In the Drawings

FIG. 3

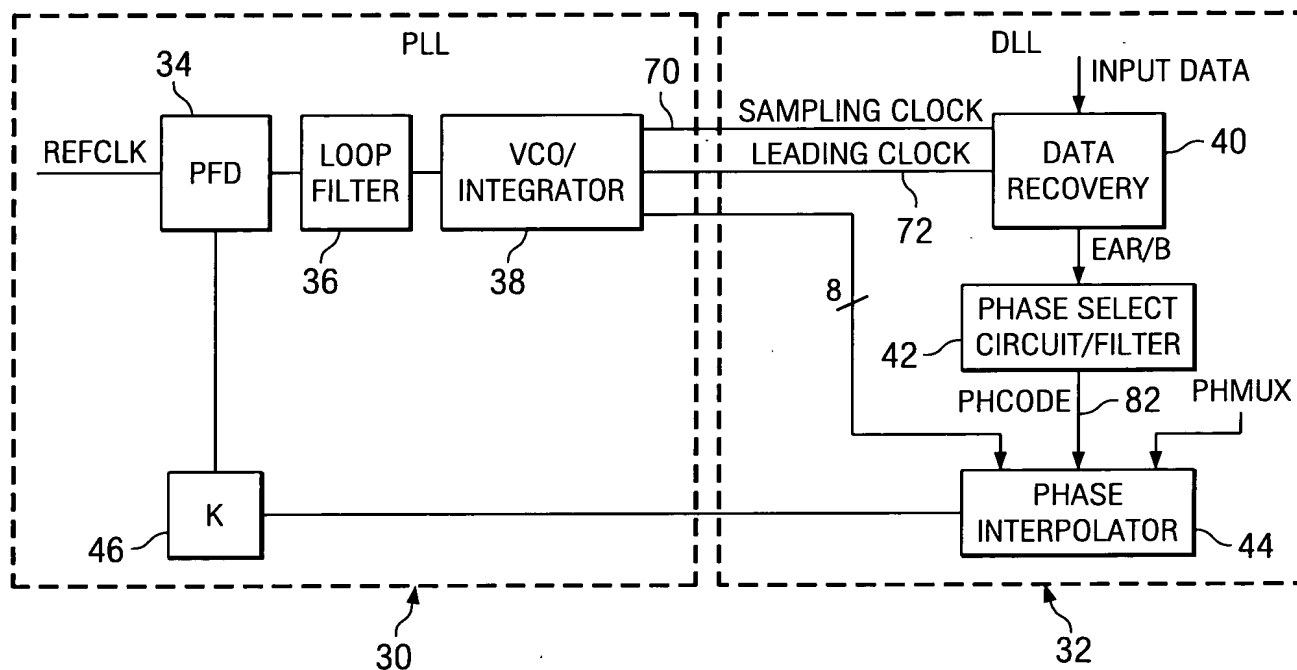
Figure 3 Move divider K 46 from DLL 32 to PLL 30.
